Consists of corrected figures showing the proper valve nomenclature and line-up related to the auxiliary feedwater system...

Donald C. Cook Nuclear Plant Unit No. 1
Docket No. 50-315
DPR No. 58

This letter clarifies and amends our letter of April 6, 1977 regarding flushing or hot functional testing of Unit No. 2 using the auxiliary feedwater system while Unit 1 is in operation. A revision is necessary to the information transmitted in this previous letter regarding the identification of the valves and the safety requirements of the auxiliary feedwater system.

FIGURE 2 UNIT 2 HOT FUNCTIONAL TESTING OR INITIAL STARTUP
UNIT 1 OPERATIONAL - WORST CASE - USING BOTH MDFPS

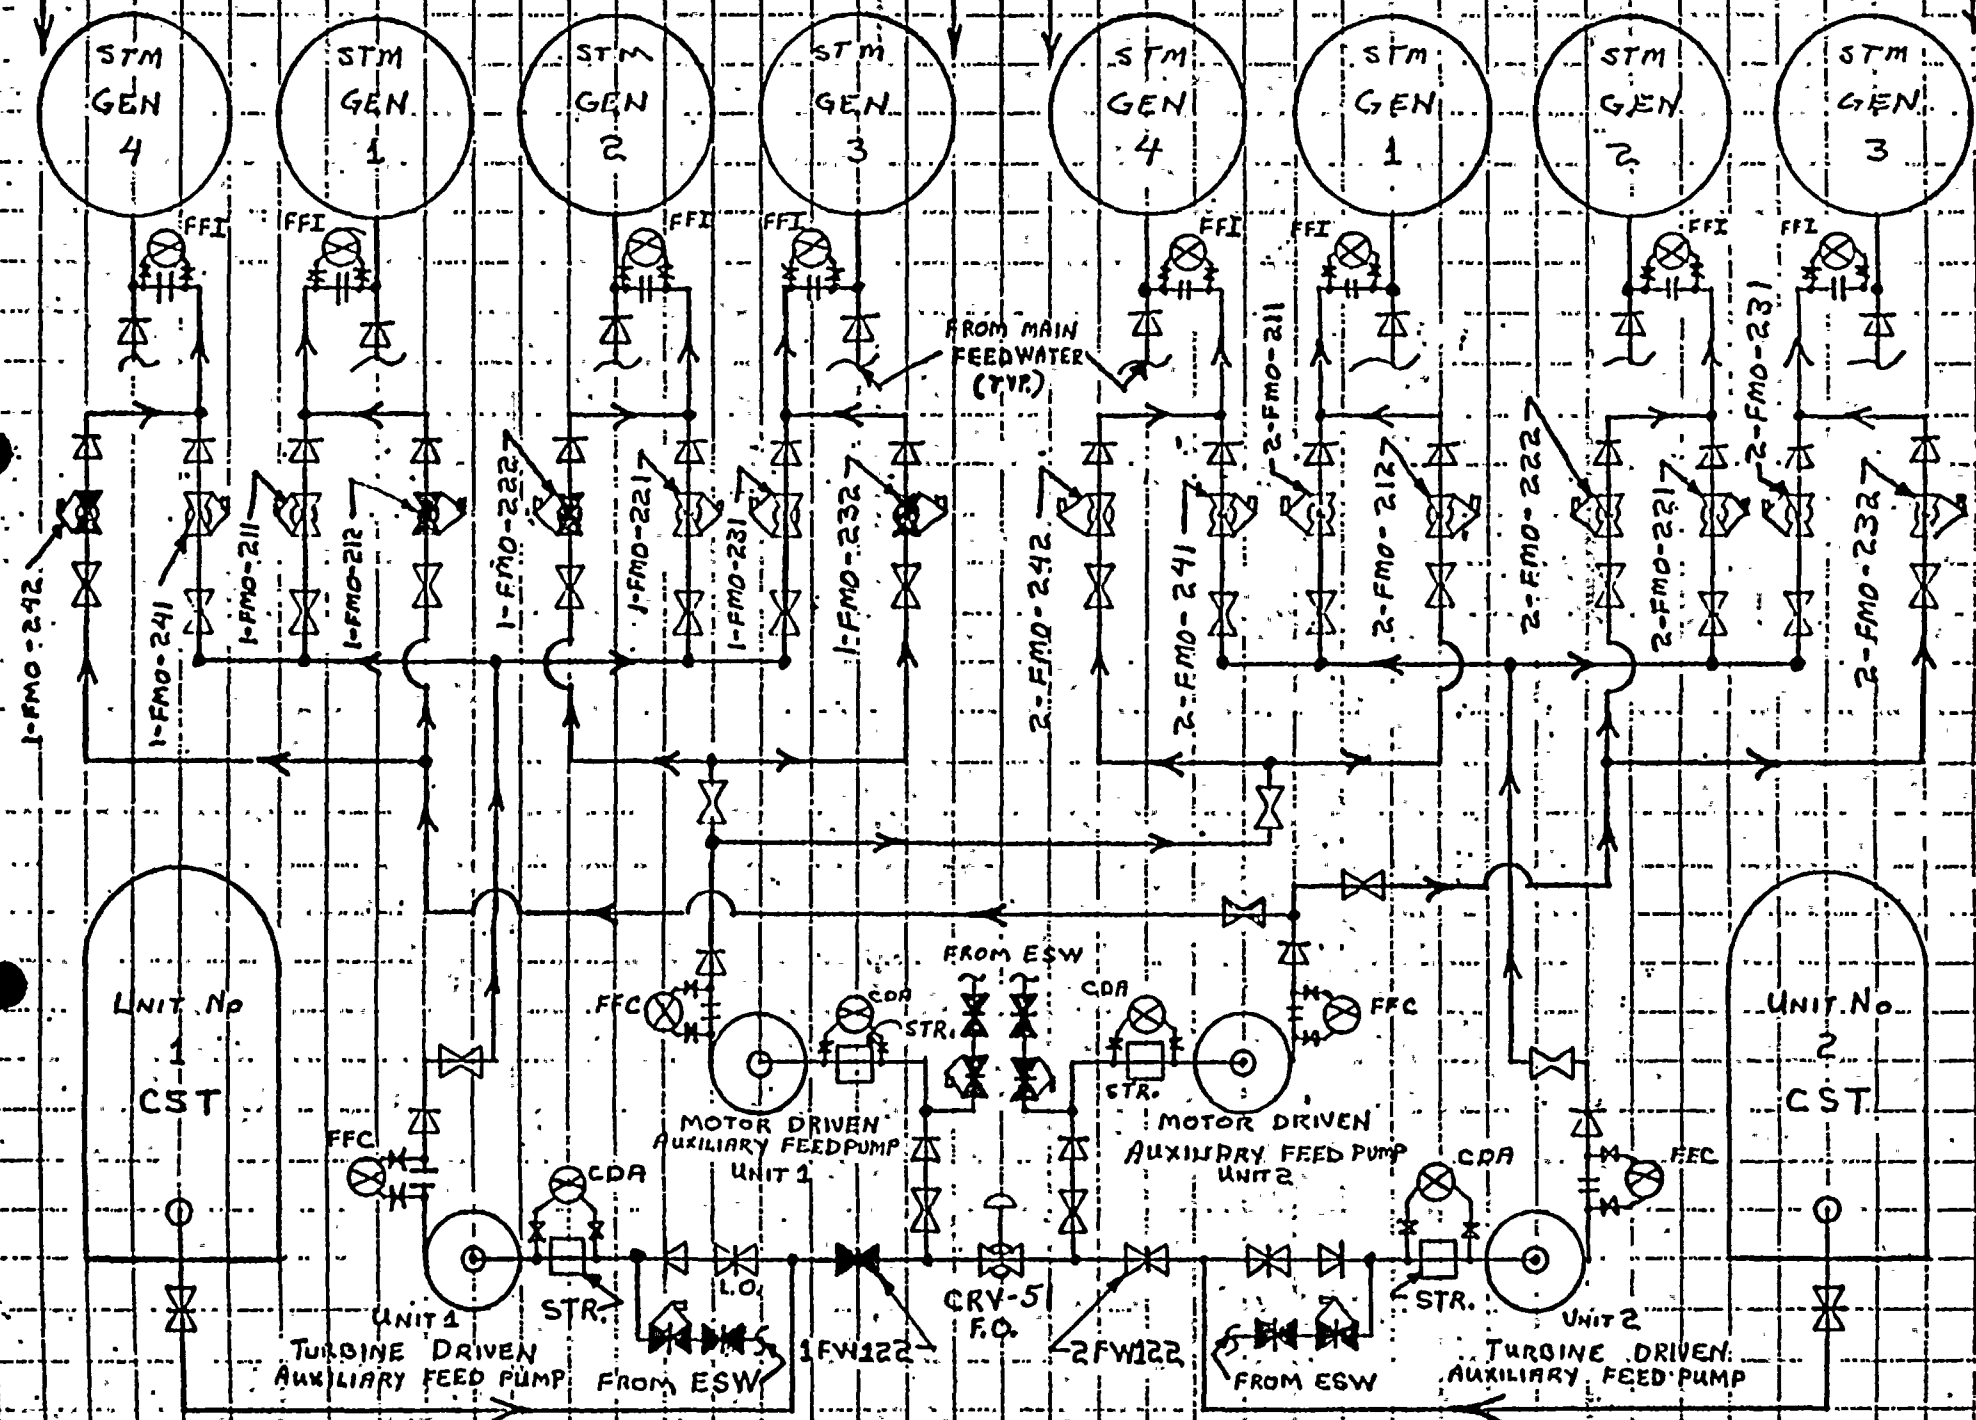
Corrected figures showing the proper valve nomenclature and line-up are attached to this letter. These figures show the valve alignment necessary to valve-out suction to the motor driven feedwater pumps from the Unit 1 condensate storage tank. In the unlikely event the auxiliary feedwater to Unit 1 is required while flushing or hot functional testing operations in Unit 2 are underway, water will be available to the motor driven feedwater pumps from the Unit 2 condensate storage tank. The auxiliary feedwater valves to Unit 2 will automatically close, and the valves from the motor-operated auxiliary feedwater pumps to Unit 1 will be opened by the operator from the control room. Further, during both flushing and hot functional testing operations, the Unit 2 condensate storage tank water volume will be maintained at a minimum of 175,000 gallons (the same as is currently required for the Unit 1 tank) by administrative control. Thus, this valve alignment replaces the Unit 2 condensate storage
